DRAWING LIST

DA SUBMISSION

PROPOSED MIXED USE DEVELOPMENT

684-700 CANTERBURY ROAD BELMORE

GFA CALCULATION

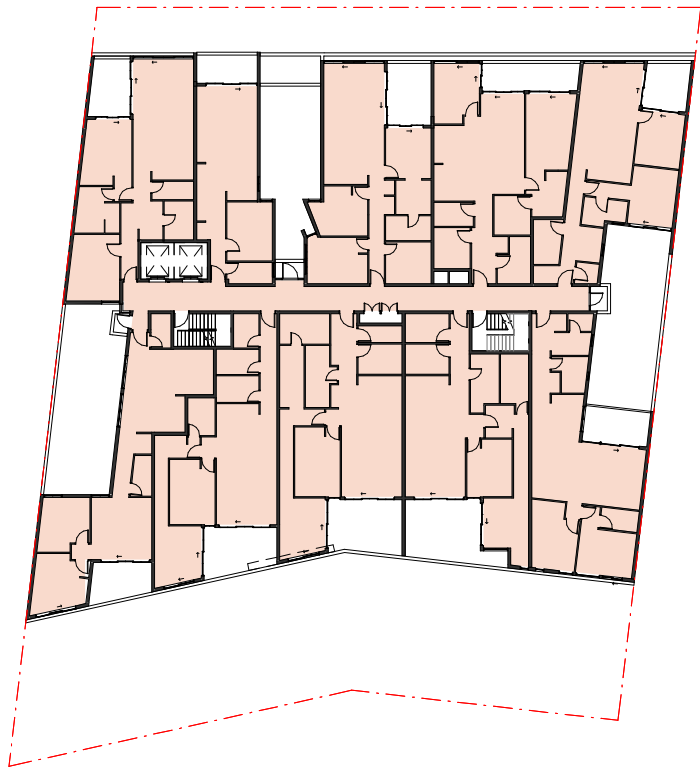
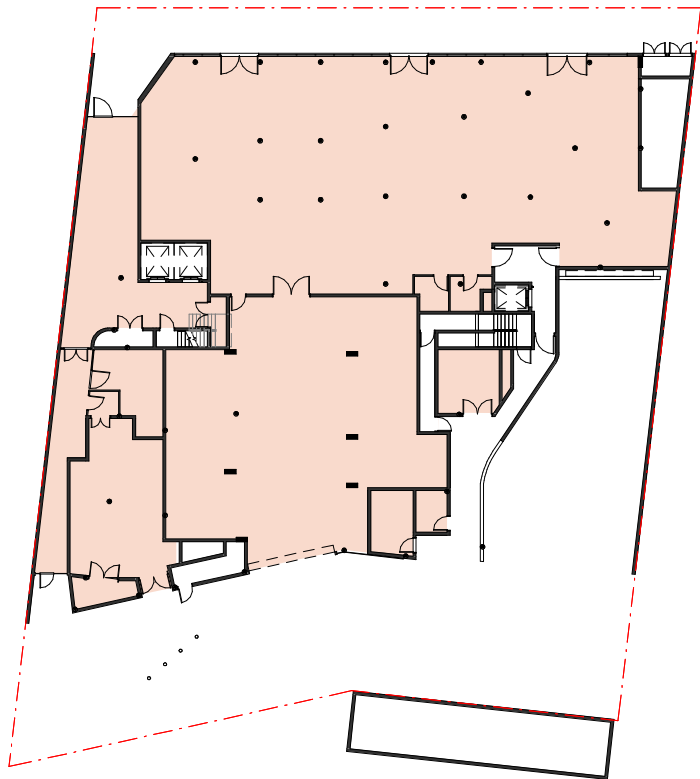
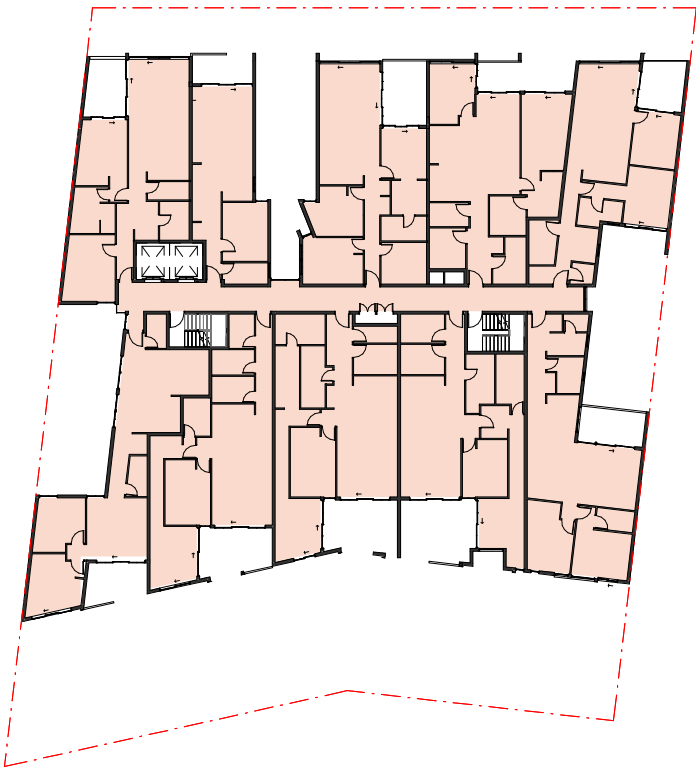
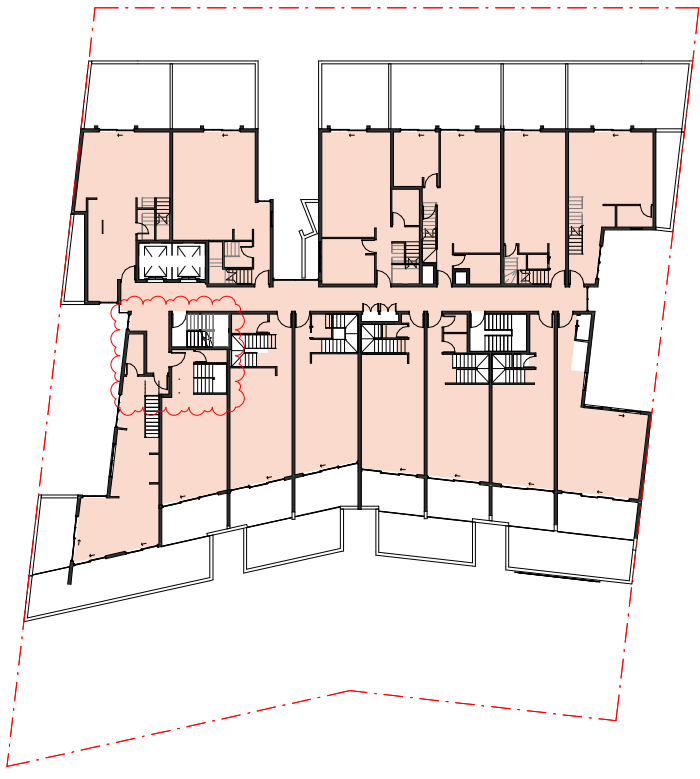
List of Changes: 23.05.22

- GFA diagrams revised
- GFA schedule revised

Drawing Title
COMMON OPEN SPACE DIAGRAM

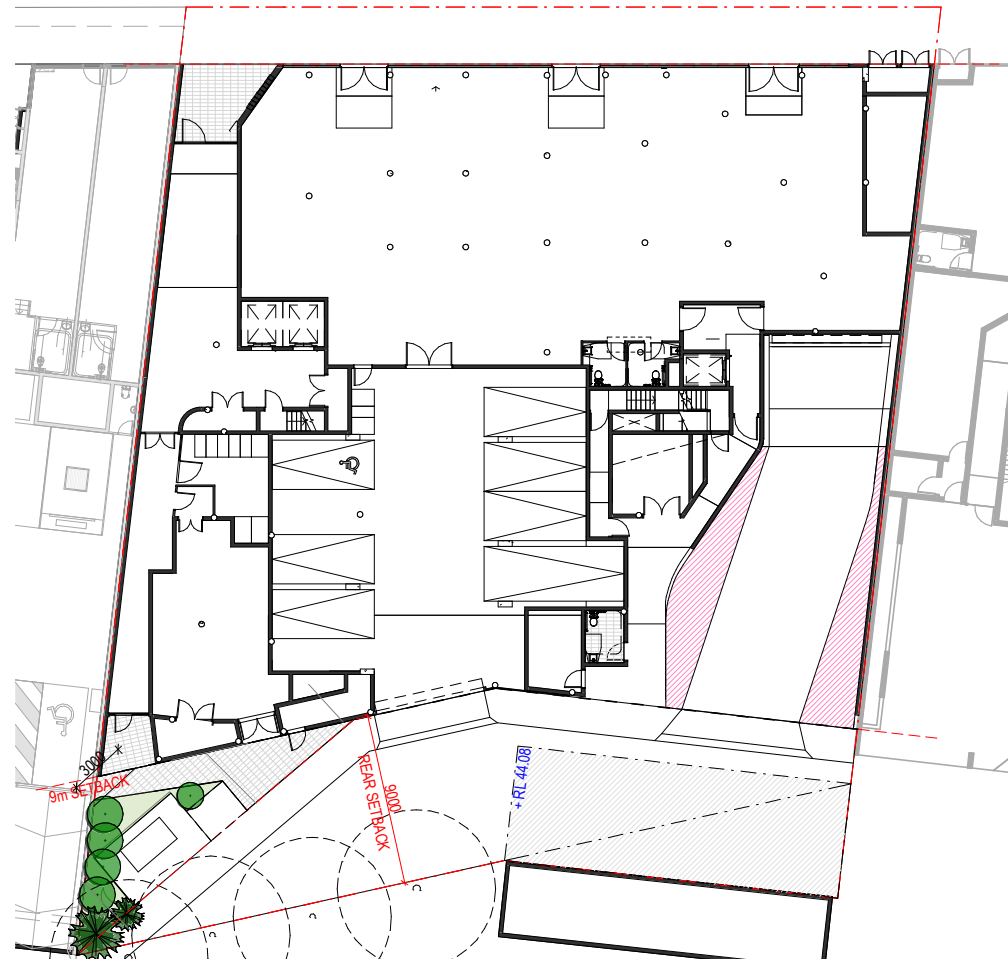
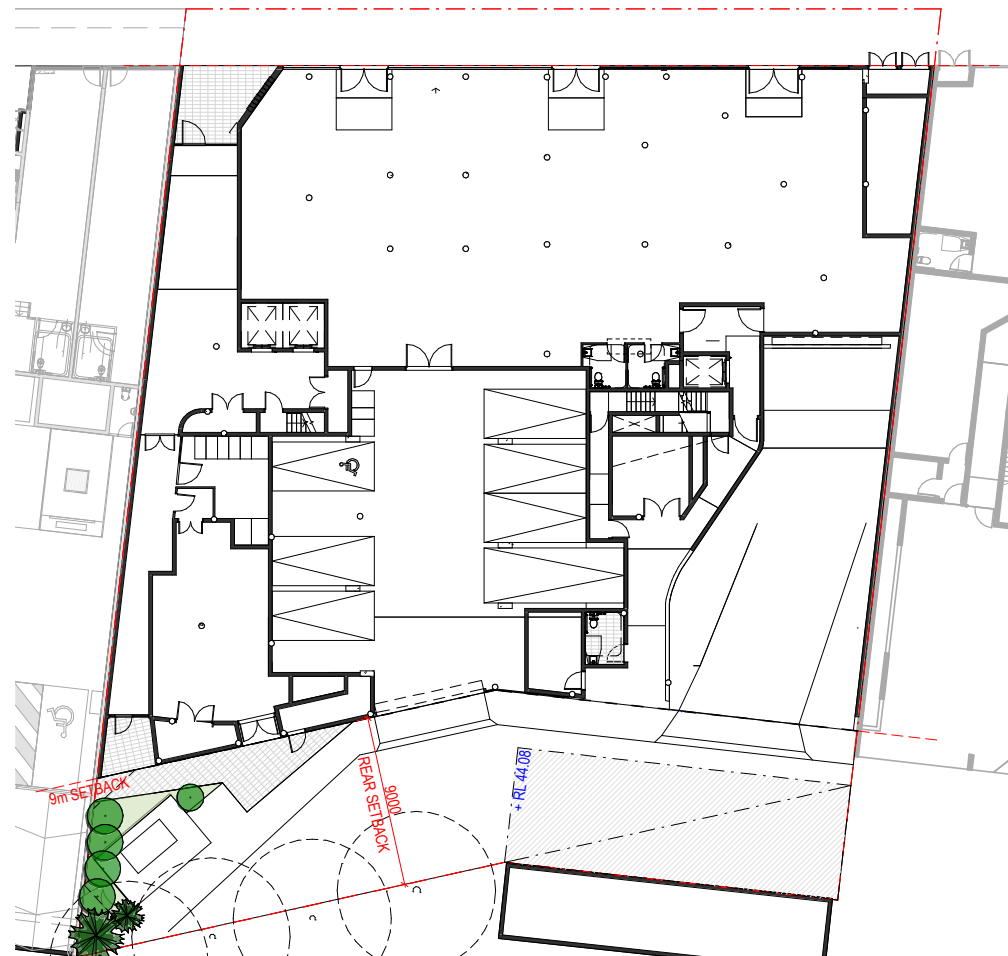
List of Changes: 23.05.22
• COS diagrams revised
• calculation revised

684-700 CANTERBURY ROAD
BELMORE
Drawing Title
COMMON OPEN SPACE SOLAR DIAGRAMS

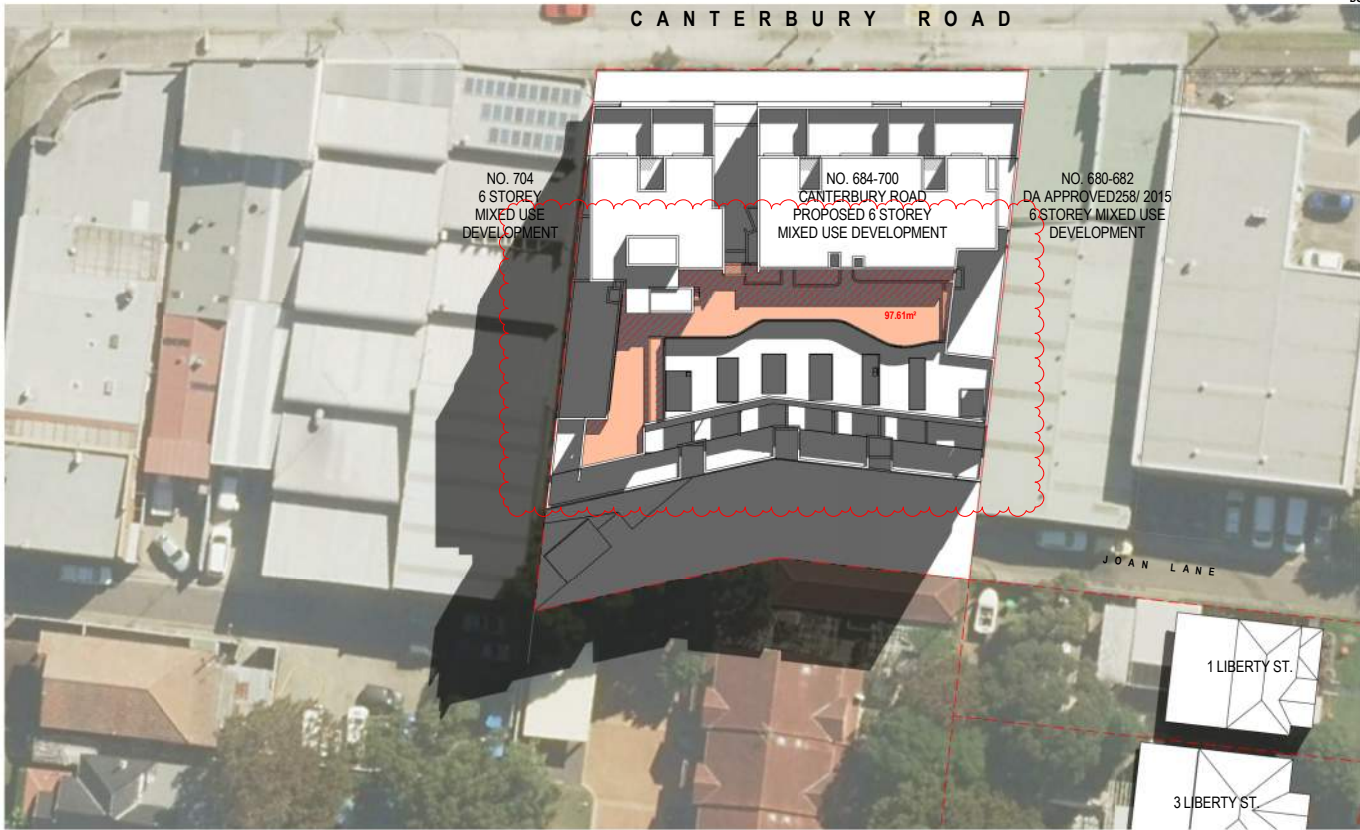
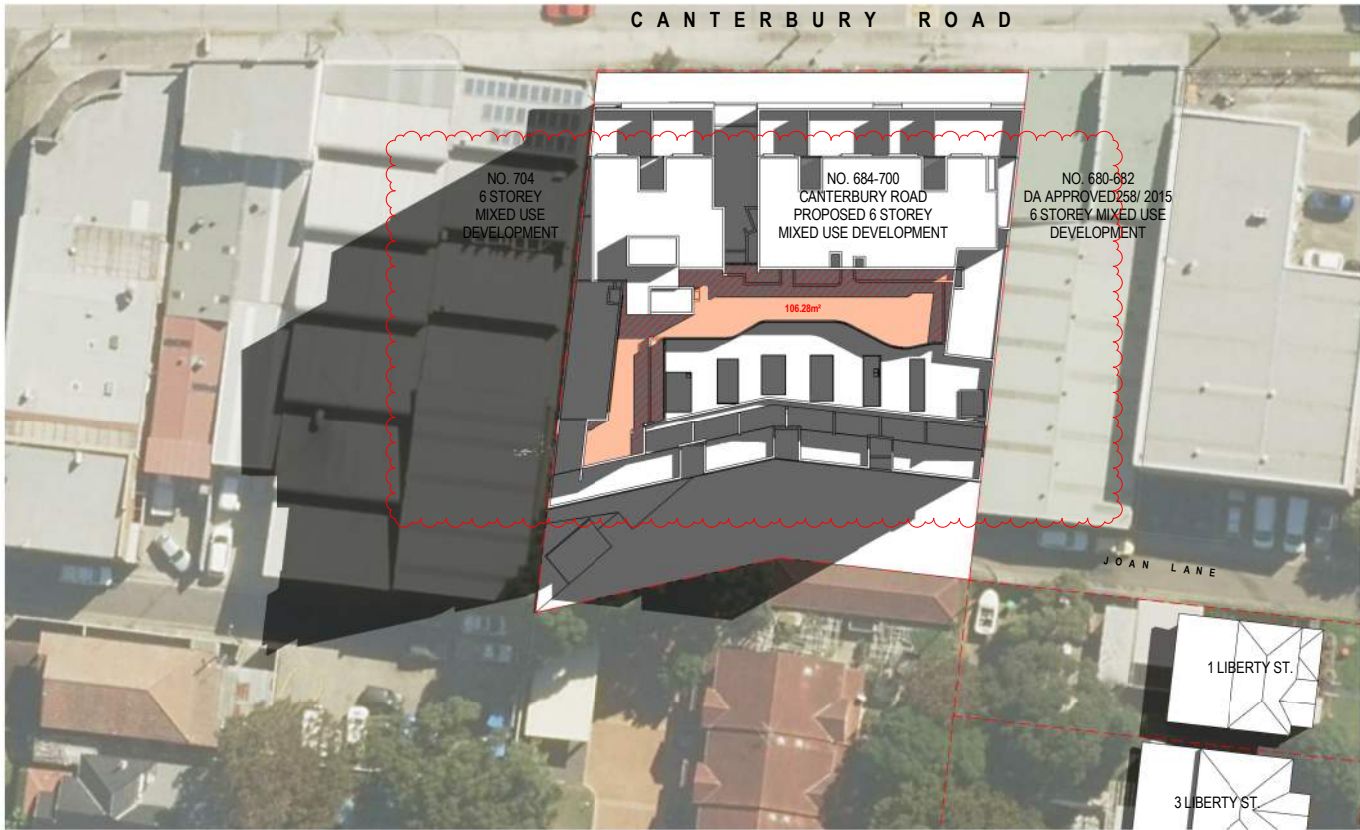
List of Changes: 23.05.22
Solar Diagrams updated

1 LEP HEIGHT BLANKET DIAGRAM VIEW 1

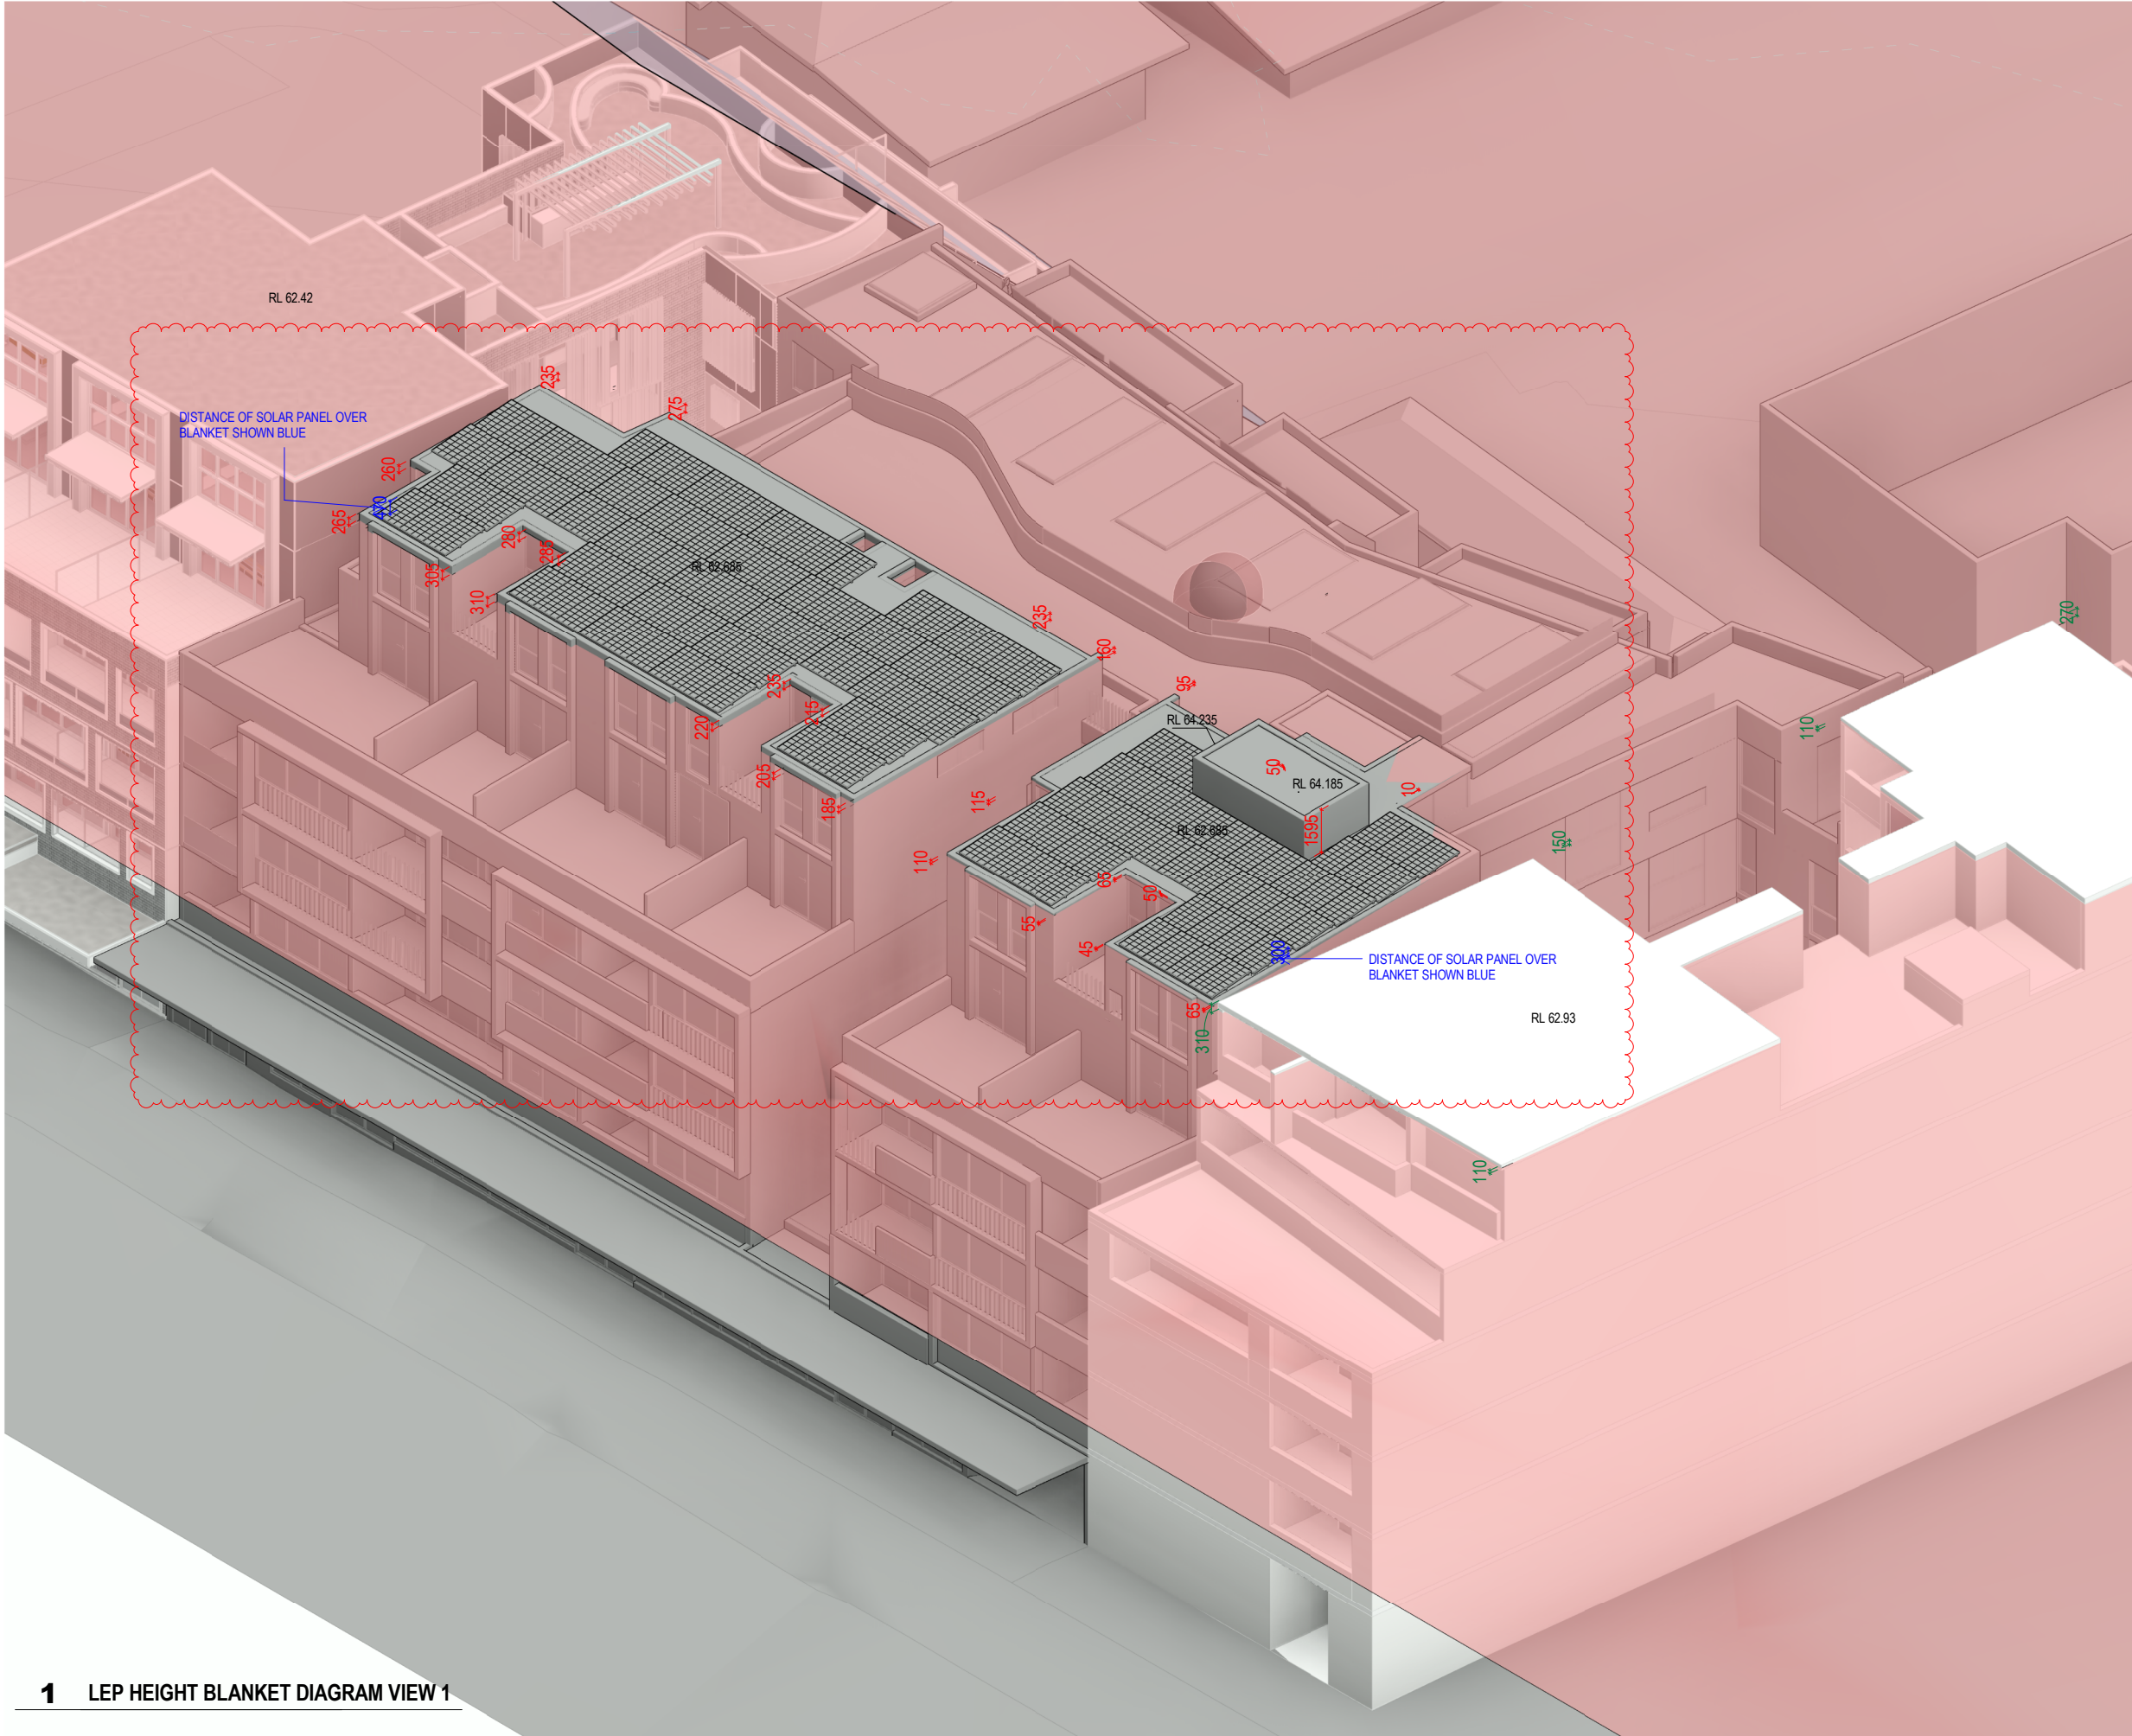
List of Changes: 23.05.22

- Blanket diagram revised as per changes on elevations and floor plans
